Access Compliance Report

Public Rights-of-Way (Curb Ramps)

Intersection ID: 42580	Main Street: GERALDINE_POWE_DR	Cross Street: RISING_OAK_DR	Location: SW
ADA ID: 879BE837CB7F	Ramp Type: Perp	Initial Pass/Fail: Pass	Overall Compliance: No
		Severity Score: 20

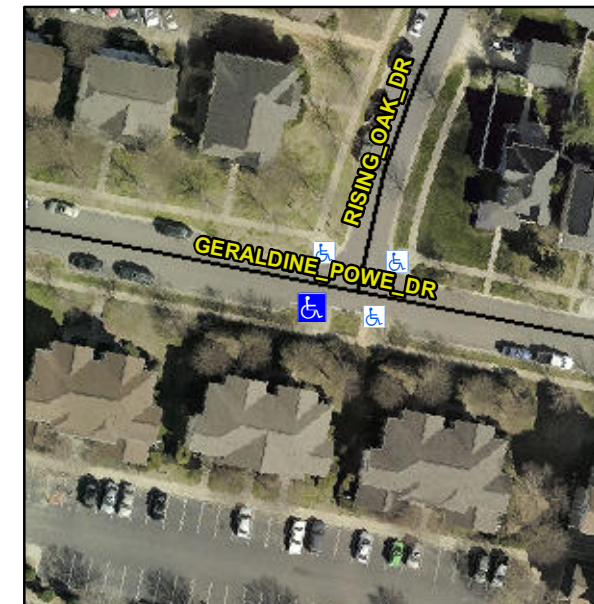
**Not Found, R304.2.1, R302.7.2,
R304.5.4**

Compliance	Description	Data	Compliance	Description	Data
N/A	Ramp Length (in)	141.0	Yes	Ramp Slope (%)	5.6
Yes	Ramp Width (in)	54.5	Yes	Ramp XSlope (%)	0.1
N/A	Flare Type LT	Sloped	N/A	Flare Type RT	N/A
N/A	Flare Slope LT (%)	8.2	Yes	Flare Slope RT (%)	9.9
N/A	Flare Traversable LT?	Yes	N/A	Flare Traversable RT?	Yes
No	Landing Length (in)	47.5	Yes	DWS Provided?	Yes
Yes	Landing Width (in)	54.5	Yes	DWS Contrast?	Yes
Yes	Landing Slope (%)	1.8	Yes	DWS Length (in)	24.0
Yes	Landing X Slope (%)	1.5	Yes	DWS Full Width?	Yes
N/A	Landing Curb? (Y/N)	No	Yes	DWS Offset (in)	1.0
N/A	Shared Landing?	No			
Yes	Gutter Ponding?	No	No	Gutter Slope (%)	6.8
No	Gutter Lip Ht (in)	1.0	Yes	Gutter X Slope (%)	0.7
N/A	Painted X Walk1?	No	N/A	Painted X Walk2?	N/A
	X Walk 1 Direction	To N		X Walk 2 Direction	N/A
N/A	X Walk 1 Width (in)	N/A	N/A	X Walk 2 Width (in)	N/A
	X Walk 1 Slope (%)	2.9		X Walk 2 Slope (%)	N/A
	X Walk 1 X Slope (%)	0.7		X Walk 2 X Slope (%)	N/A

**Remove & Replace Entire Ramp.
Remove & Replace Gutter.**
